Well Name: CANAL 20/19 FED COM	Well Location: T21S / R27E / SEC 20 / NENE / 32.4701552 / -104.2047139	County or Parish/State: EDDY / NM
Well Number: 714H	Type of Well: CONVENTIONAL GAS WELL	Allottee or Tribe Name:
Lease Number: NMNM0354232	Unit or CA Name:	Unit or CA Number:
US Well Number: 3001557073	Operator: MEWBOURNE OIL COMPANY

Notice of Intent

Sundry ID: 2866423

Mewbourne Oil Company requests that the following change be made to the Canal 20/19 Fed Com #714H (API 30-015-57073):

CANAL 20/19 FED COM #714H

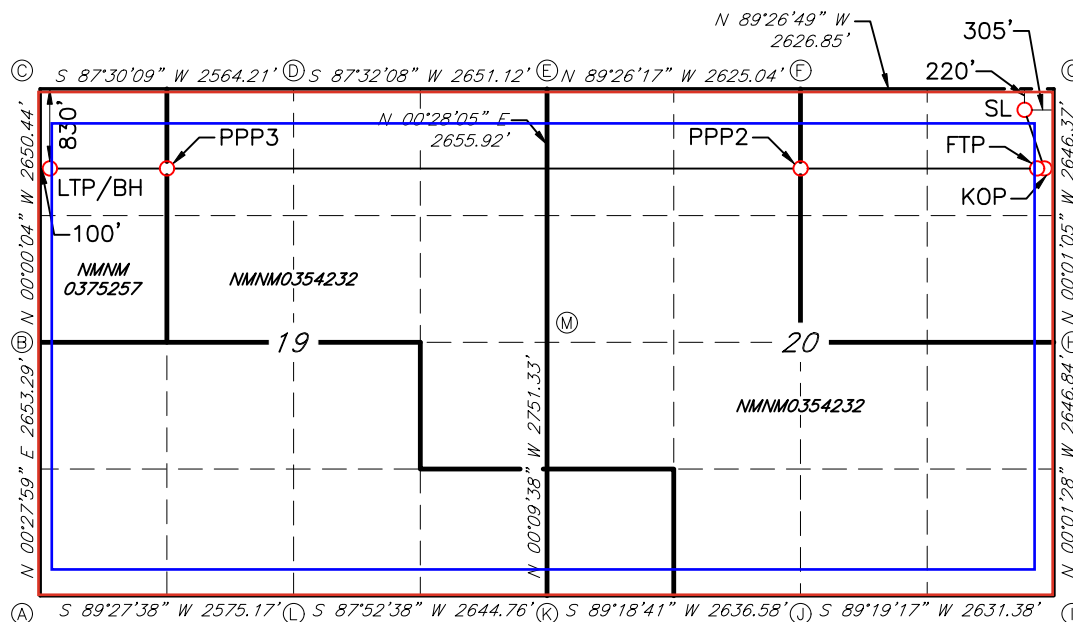
- Change SHL f/ 960 FNL & 355 FEL (20) to 220 FNL & 305 FEL (20)
- Change BHL f/ 2150 FNL & 100 FWL (19) to 830 FNL & 100 FWL (19)
- Attached C102, Dir Plan & Plot, Drlg Program reflecting requested changes.

SURFACE LOCATION (SL)
220' FNL & 305' FEL SEC.20
N: 535536.5 - E: 581053.0

LAST TAKE POINT/BOTTOM HOLE (LTP/BH)
830' FNL & 100' FWL SEC.19
N: 534753.5 - E: 570998.1

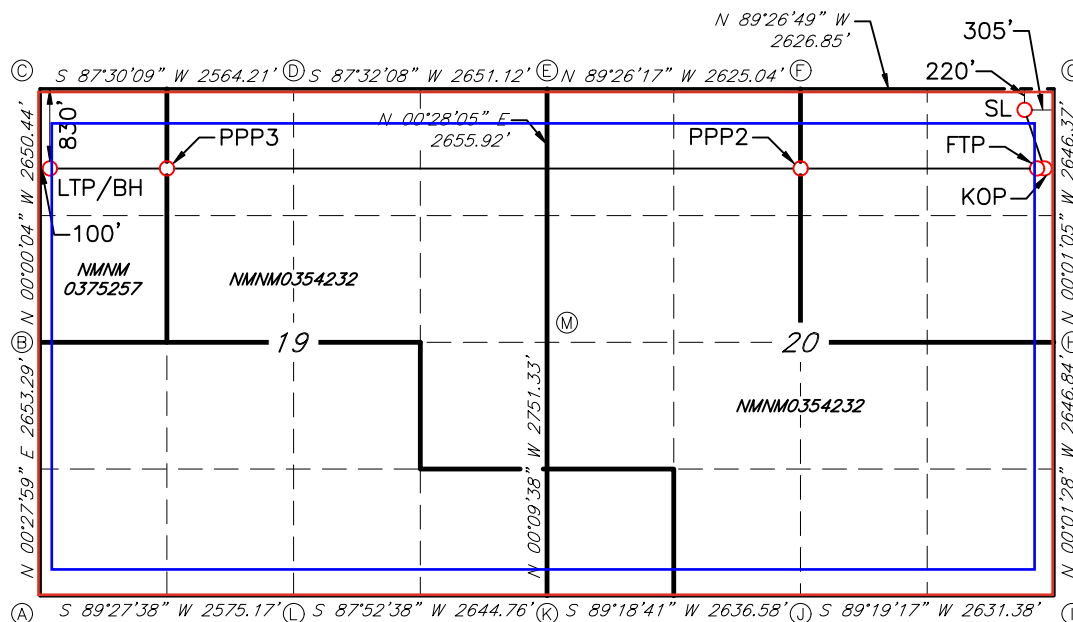
- Change SHL f/ 960 FNL & 355 FEL (20) to 220 FNL & 305 FEL (20)
- Change BHL f/ 2150 FNL & 100 FWL (19) to 830 FNL & 100 FWL (19)
- Attached C102, Dir Plan & Plot, Drlg Program reflecting requested changes.
